SUBJECT: Forwards addl info re NUREG-0737, Item III.D.3.4, "Control Room Habitability Requirements," per 830106 request. Design changes made & justification provided for unsubstantial backfit items, per 830307 ltr.

Re: Turkey Point Units 3 & 4
Docket Nos. 50-250 & 50-251
Post TMI Requirements
Control Room Habitability
NUREG-0737 Item III.D.3.4

Re: Turkey Point Units 3 & 4
Post TMI Requirements
Control Room Habitability
NUREG-0737 Item III.D.3.4

Figure 1
SIMPLIFIED
FLOW DIAGRAM OF
TURKEY POINT CONTROL
ROOM HVAC

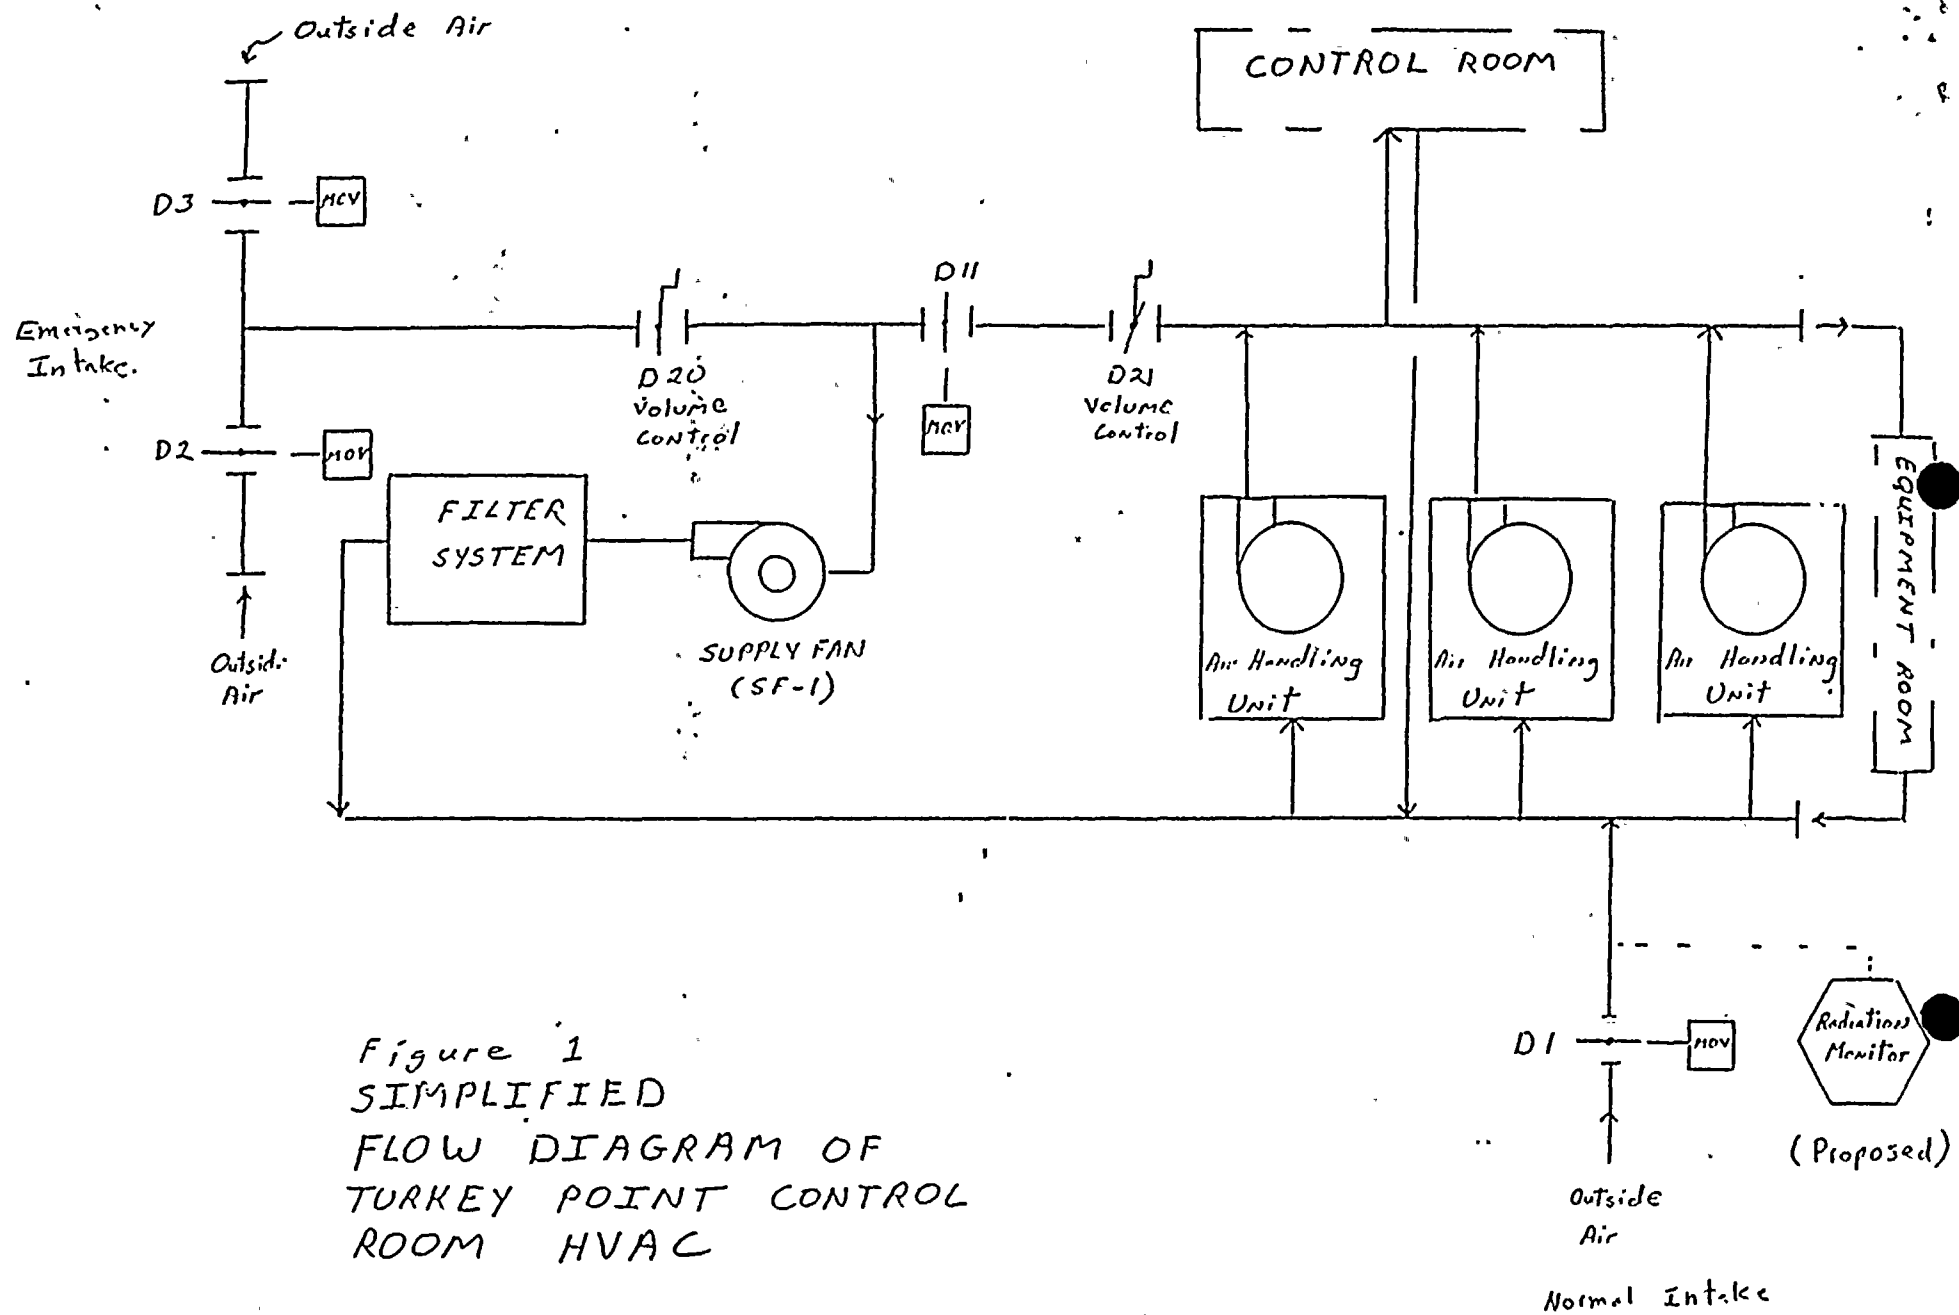
"The control room habitability systems, as engineered safety features, must be capable of performing their safety-related function given the failure of any single active component. It appears, based on the information provided, that the failure of any one of the following active components could result in the loss of the required ventilation system functions:

- a) normal intake isolation damper, D-1
- b) emergency supply fan, SF-1
- c) volume control damper, D-20

In addition, it would be necessary to close volume control damper D-20, if either emergency intake damper D-2 and D-3 were unable to close when isolation and recirculation were demanded. The July 22, 1982, response refers to D-20 as "fixed".

Provide justification that the failure of any one of the active components identified above will not result in the loss of the required ventilation system safety functions or provide proposed design modifications".

"To comply with GDC-19, the staff requires radiation monitors in the normal air intake to initiate isolation of that intake upon detecting radiation well above background and for radiation monitors in the emergency intakes to permit operators to minimize control room doses in the event of an accident.

Provide additional justification or a commitment to install radiation monitors in the normal and emergency air intakes".

FPL does not intend to install radiation monitors in the emergency air intakes. The basis for the regulatory guidance to install these detectors is embodied in the preliminary review of the Turkey Point Control Room Habitability Study conducted by Battelle Pacific Northwest Laboratories (Reference (c)). The review recommended that "... airborne radiation monitors need to be installed in each of the emergency air intakes so that the operator can readily identify which air intake can be utilized without compromising the habitability of the control room".

The design of the Control Room HVAC system, which is an emergency system and not an engineered safety system, is not single-failure proof, nor would there be a sufficient increase in safety to justify the additional expense of making it so. Following the Control Room Habitability Study, FPL began an extensive program upgrading the HVAC system to allow pressurization of the control room following an accident to reduce potential in-leakage and keep operator exposure below the limits of GDC-19. This modification includes the replacement of the multiple blade normal intake damper (D-1) with a single blade, tight sealing damper. The replacement is a reliable, low leakage, tight fitting, qualified damper with a back-up handwheel. This handwheel provides for back-up operation in the event that an electrical malfunction results in a failure to isolate the normal intake. If indeed the damper should fail during the unlikely event of a design basis accident, electrical failure would clearly be the most likely failure mode and the HVAC system functional capability would be preserved through manual operation. Since the cost to install an additional normal intake damper is in excess of \$100,000, FPL does not consider this modification to be cost-effective and does not intend to backfit the HVAC system to accommodate this item.

Damper D-20 is a fixed position, volume control damper that performs no active function once it is positioned during initial HVAC balance. In order to maintain operator exposures below the requirements of GDC-19 this damper is adjusted to provide a predetermined filtered emergency air intake following an accident. It does not serve an isolation function since filtered intake is provided to remain within the dose limits of GDC-19. On an isolation signal dampers D-2 and D-3 open to provide emergency intake air and thus D-20 is not needed as a redundant isolation damper. See Figure 1.

This statement implies a misunderstanding of the operation of the control room HVAC system. The following is a description of the operation of this equipment. (See Figure 1 for details).

Upon receipt of an isolation signal (containment Phase A isolation, high radiation at plant stack, or normal HVAC intake high radiation) the control room HVAC will automatically isolate the normal intakes and exhausts, open the emergency intakes, and line up and start the emergency supply fan (SF-1). This provides a filtered intake that is used to pressurize the control room. Additionally, some of the recirculated control room atmosphere is routed through the filters for purification.

Damper D-20 is a fixed volume control damper adjusted to provide a predetermined flow (250 cfm) of outside air to the filter. This flow is required to maintain control room pressure to prevent infiltration of unfiltered air. Damper D-21 is also a fixed volume control damper adjusted to provide a constant recirculated purification flow (750 cfm). Neither of these dampers is positioned after the initial ventilation system balance.

The operation of the emergency air intake during the Maximum Hypothetical Accidental (MHA) is not optional. The control room atmosphere is maintained in a safe condition by operation of a filtered intake. If the emergency air intake is not utilized, then unfiltered bypass leakage will occur which may create a potentially hazardous condition. Our radiation analysis performed for the Control Room Habitability Study based on the MHA showed that doses would be within GDC-19 limits only through the use of the emergency air intake and it is our position that the emergency intake be used. There is no total recirculation mode for Turkey Point.

Apparently Battelle's concern about radiation monitors in the emergency intake originates from the assumption that the operator should have information available to indicate which emergency intake is supplying more contaminants so that isolation of that intake can be initiated. From a meteorological viewpoint, there is no significance as to which emergency intake is open since both draw

from approximately the same atmospheric location. Therefore, the radiation monitors in the two emergency intake lines would not provide the operator with meaningful information from which to perform any isolation function.
